From: [Jared Bouchard](#)
To: [FCGMA](#)
Subject: Pleasant Valley County Water District comments on Draft First Periodic Evaluations of the GSP for Oxnard Subbasin and Pleasant Valley Basin
Date: Monday, October 7, 2024 1:20:13 PM
Attachments: [PVCWD Comments on Draft First Periodic Evaluations of the Groundwater Sustainability Plans for the Oxnard Subbasin and Pleasant Valley Basin.pdf](#)

Re: Pleasant Valley County Water District Comments on Draft First Periodic Evaluations of the Groundwater Sustainability Plans for the Oxnard Subbasin and Pleasant Valley Basin, dated August 2024

Figure 1
PVCWD Future Baseline Water Supplies Used in Draft GSP Period Evaluation Reports

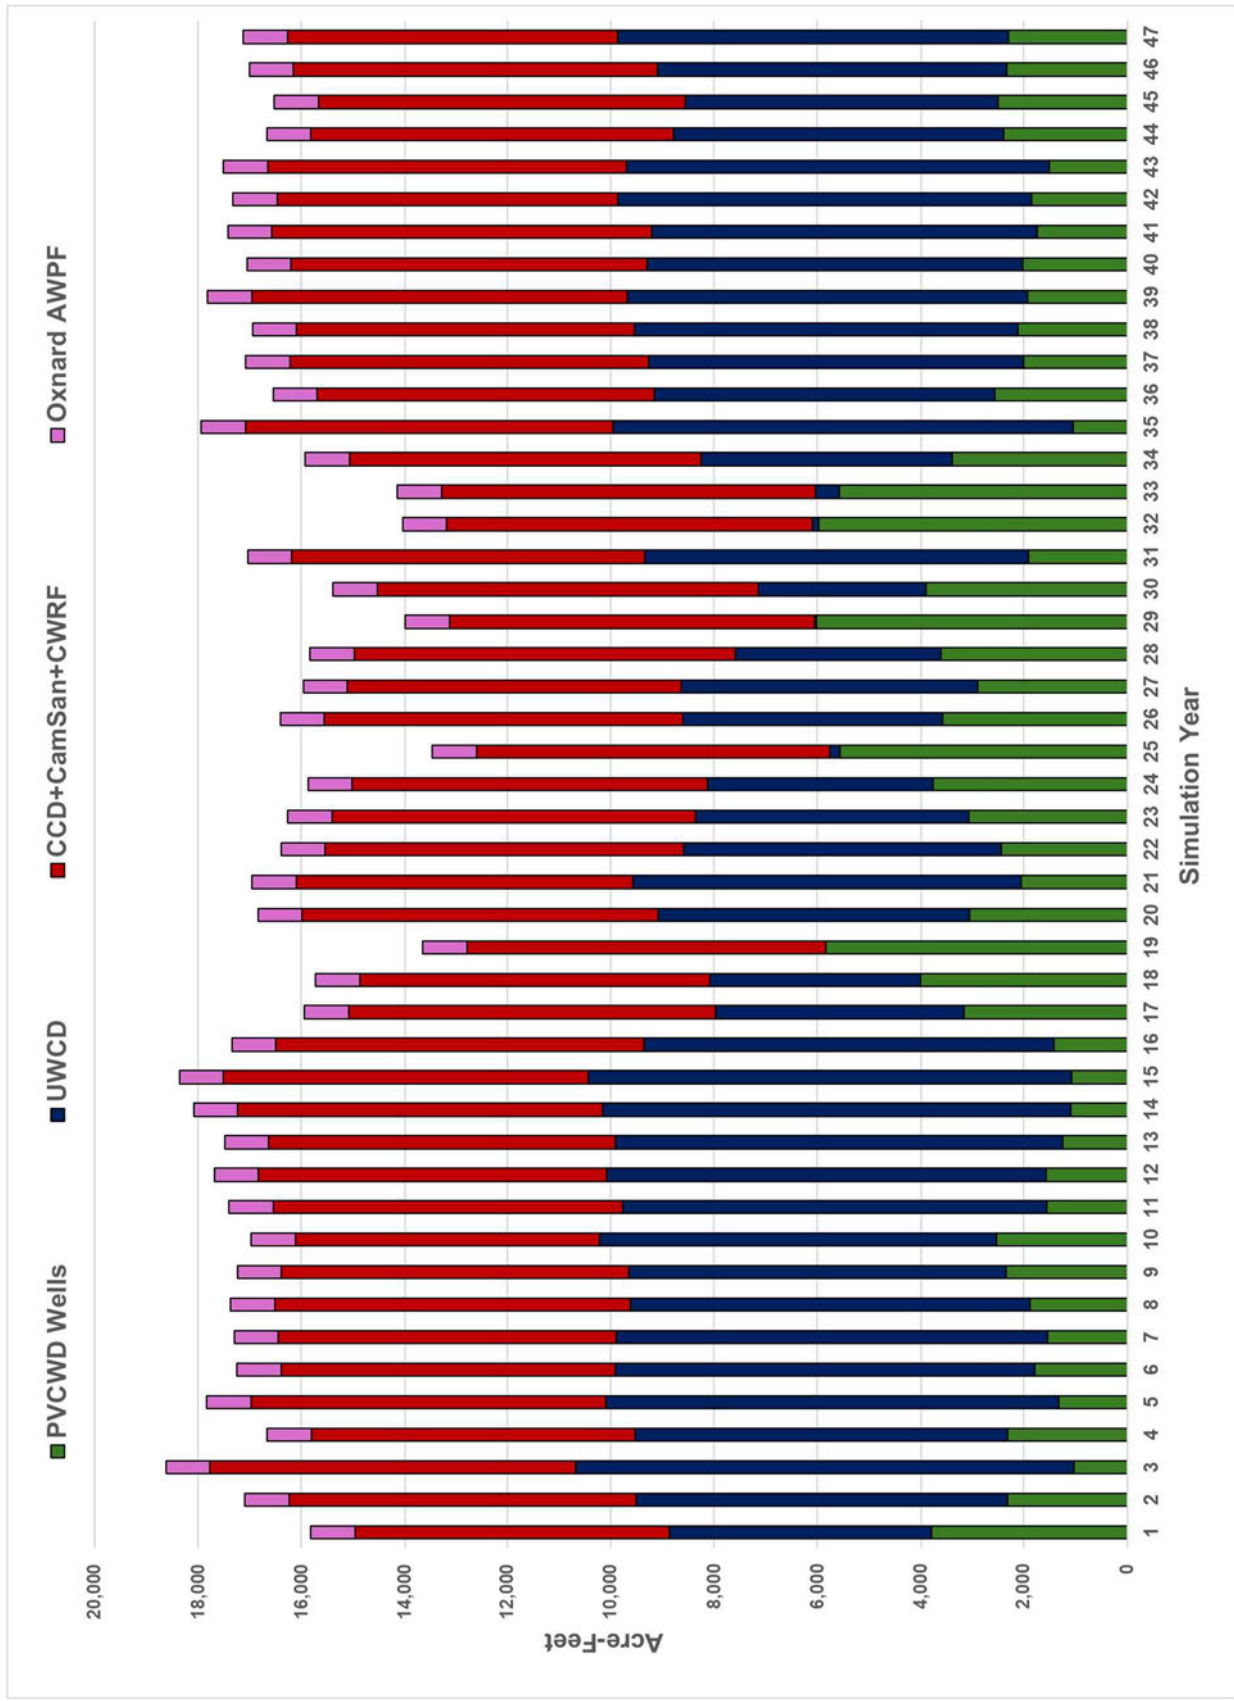
PVCWD also evaluated the annual variability in the assumed future PVCWD baseline water supplies. Figure 1 shows stacked bars showing the annual variability in the assumed baseline PVCWD water supplies by source and the total assumed PVCWD baseline water supply. The range of total assumed PVCWD baseline water supply seems reasonable when compared with the current average; however, it is noted that PVCWD has delivered significantly more water in the past, as shown in Figure 2. Additionally, supplies are larger in wet periods and vice versa, which is contrary to the historical pattern, as shown in Figure 2.

Figure 2
PVCWD Water Supplies Versus Precipitation
Historical and Future Baseline

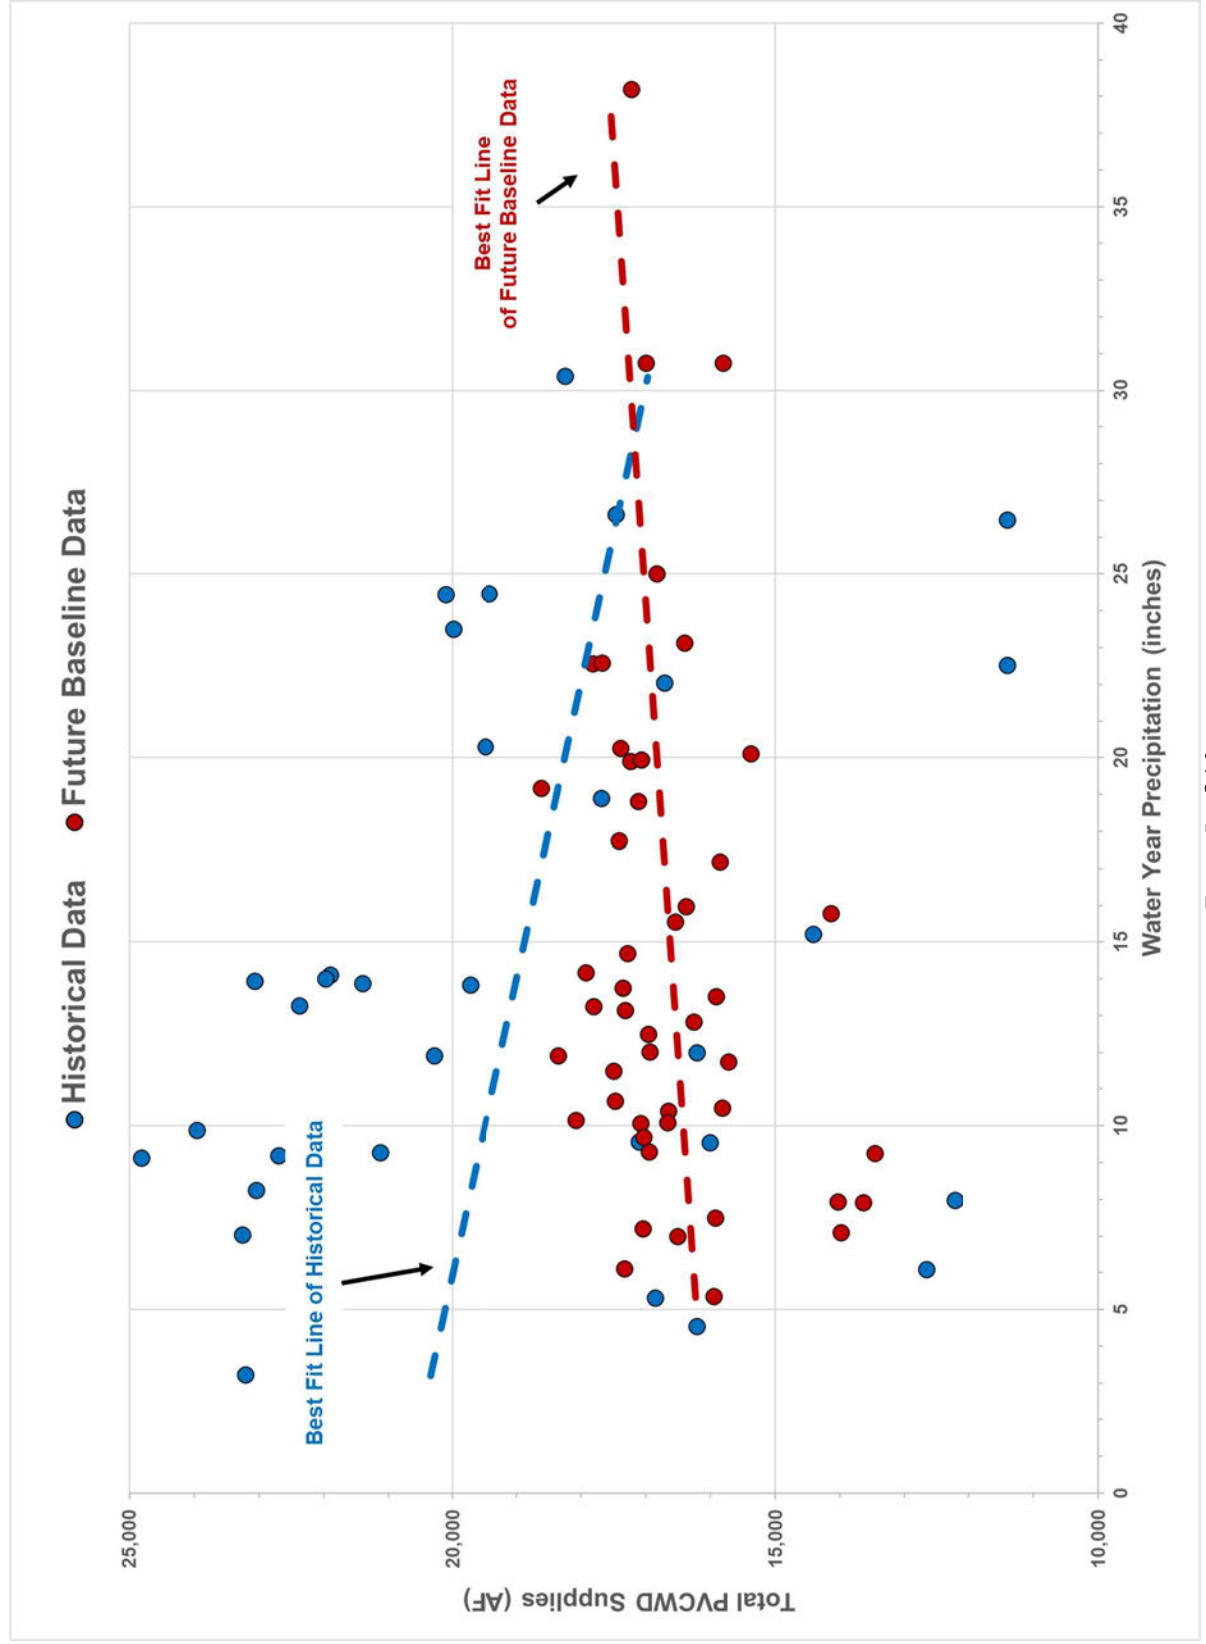
- The assumed PVCWD water demands are too low. Per the UWCD methodology the demands may be as much as approximately 2,400 AFY low (Table 2).
- The variability of supplies/demands does not follow expected pattern of decreasing in wet year and increasing in dry years (Figure 2).
